PCN No#: 031422-1

PCN Title: Additional Qualified Assembly and Test(A/T) Site.

PRODUCT CHANGE NOTICE

Table A - Appearance comparison	
Site 1(Current)	Site 2(New)

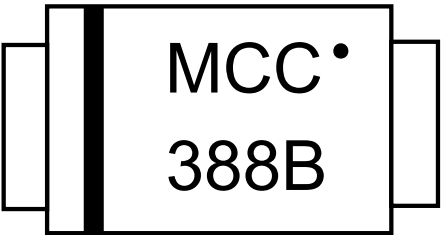
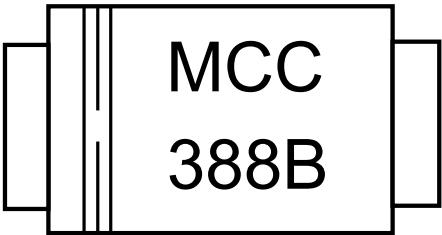
Notification Date	Implementation Date	Change Type	Classification	PCN No
Mar 14, 2022	Jun 14, 2022	Additional Qualified A/T	Major	031422-1
TITLE				
Additional Qualified Assembly and Test(A/T) Site.				
DESCRIPTION OF CHANGE				
This PCN is being issued to notify customers that in order to assure continuity of supply, MCC has qualified additional Assembly and Test Site. Full electrical characterization and high reliability testing has been completed to ensure there is no change to device functionality or electrical specifications in the datasheet.				
IMPACT				
No change in datasheet electrical parameters and product performance. Table A: Appearance comparison				
PRODUCTS AFFECTED				
See Table B below for the products affected.				
WEB LINKS				
Terms And Conditions:	https://www.mccsemi.com/Home/TermsAndConditions			
For More Information Contact:	https://www.mccsemi.com/Contact/Index			
Products:	https://www.mccsemi.com/ProductCategories
